From: "Anne Zareh" <anne.zareh@braziermotti.com.au>
Sent: Wed, 29 Jul 2026 16:50:36 +1000
To: "Development Assessment" <developmentassessment@townsville.qld.gov.au>
Cc: "Jayne Carter" <jayne.carter@townsville.qld.gov.au>; "Dale Armbrust" <dale.armbrust@townsville.qld.gov.au>
Subject: MCU26/0040 - Further Advice Assessment Manager- 13 Market Street BURDELL
Attachments: FA Response.pdf

Response to Further Advice – P004169 (MCU26/0400)

NORTH SHORE PRECINCTS 2 & 3 - STAGE 201

Q50 STORMWATER CATCHMENT PLAN

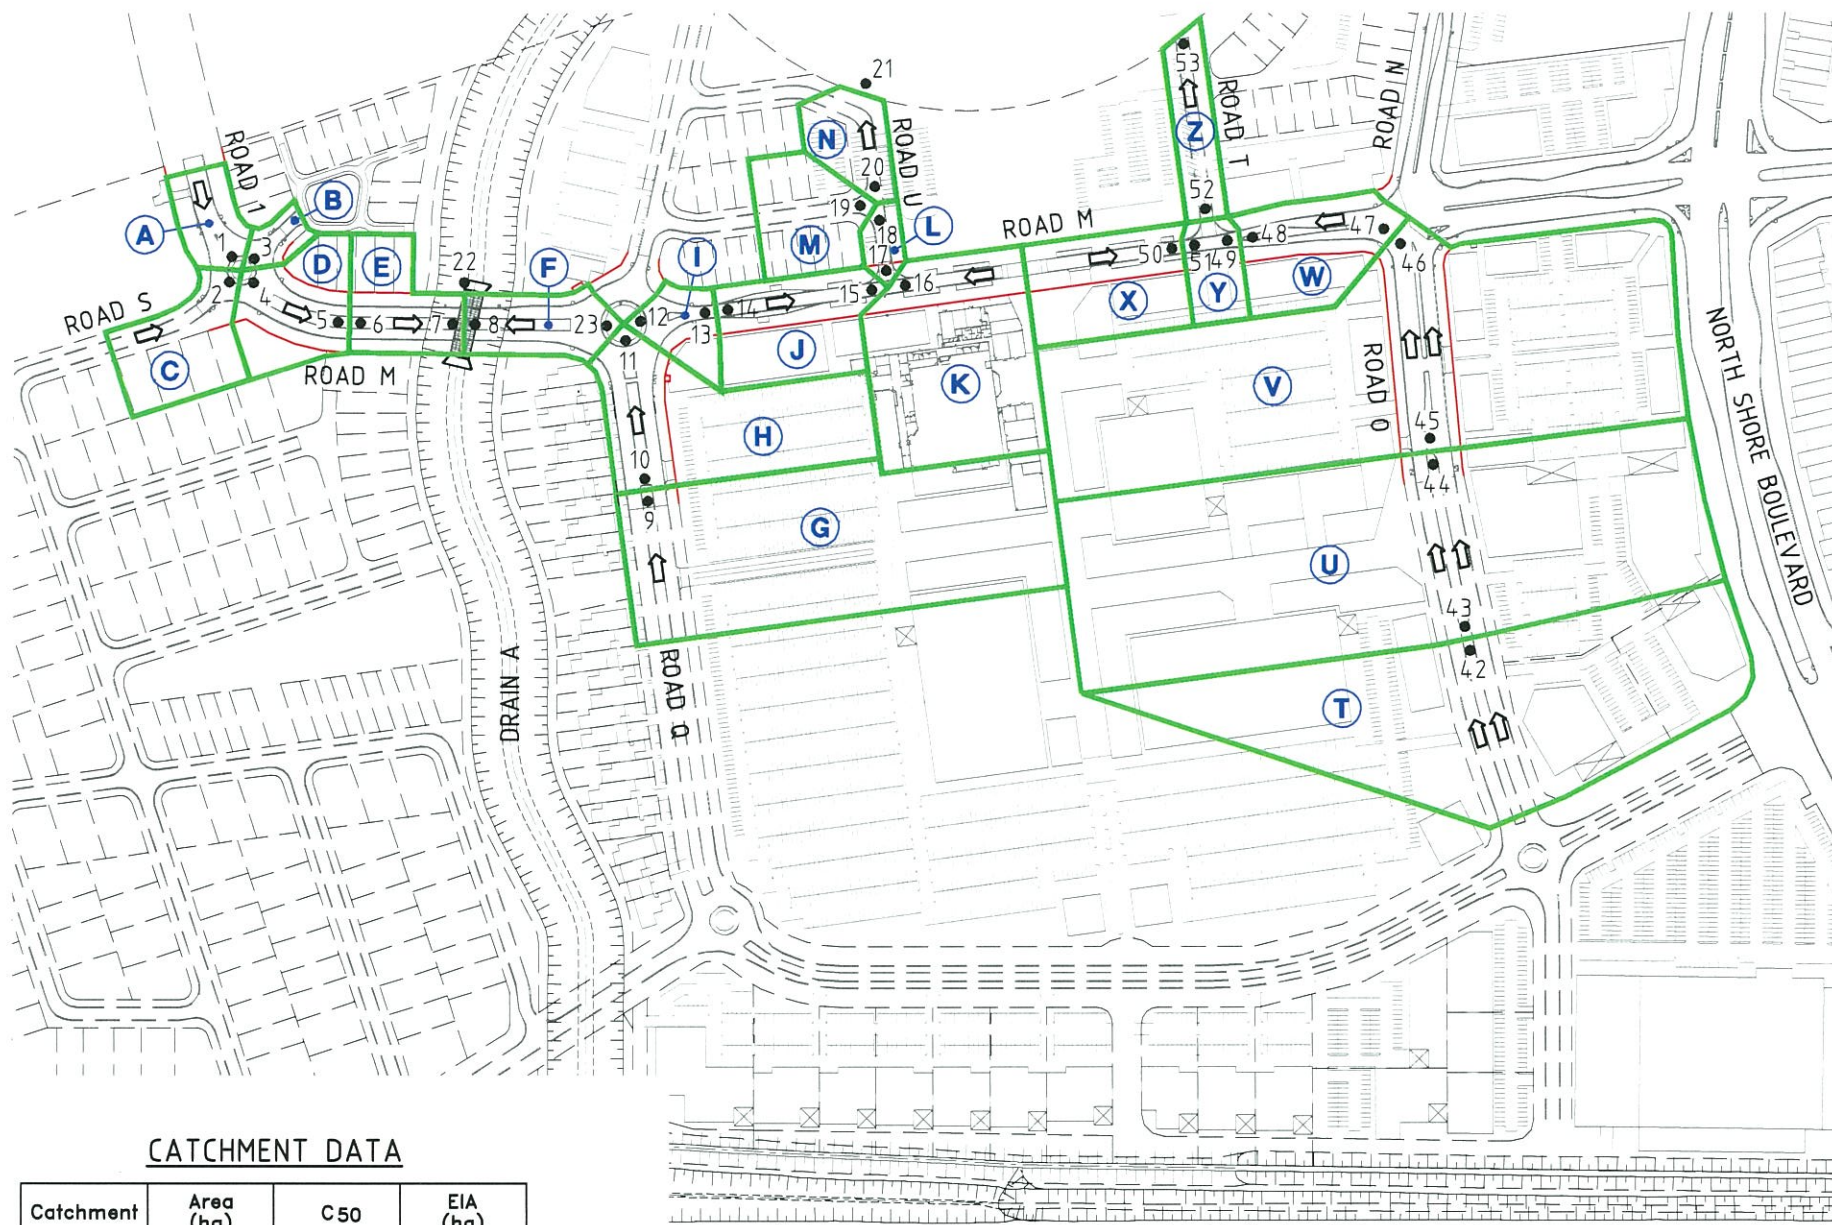
In response to Council's comments regarding the predicted 1% AEP afflux (100–200 mm) within Market Street east of the development site, we note the following.

Market Street was originally designed to accommodate runoff from the subject development area. As shown on the approved stormwater catchment plan (Drawing STG004/85), Market Street forms part of the intended drainage network for Catchments T, U and V. These catchments are broadly consistent with the contributing catchment identified in Figure 2.5 of the Flood Impact Assessment.

Accordingly, the conveyance of runoff through Market Street is not a new consequence of the proposed development, but rather an outcome that was anticipated and incorporated into the approved drainage design.

The afflux identified within the Flood Impact Assessment was therefore expected. Our review indicates that Council's flood model does not fully account for the existing approved drainage infrastructure and overland flow arrangements within Market Street. As a result, the model does not accurately represent the hydraulic behaviour intended under the approved stormwater design.

Accordingly, the identified afflux is considered to reflect limitations in the representation of the approved drainage infrastructure within the underlying flood model rather than an adverse flooding impact caused by the development.

On this basis, we consider that additional mitigation measures are not warranted, as the approved drainage network already provides for the conveyance of runoff from the contributing catchments and the development does not materially alter the intended flood conveyance function of Market Street.
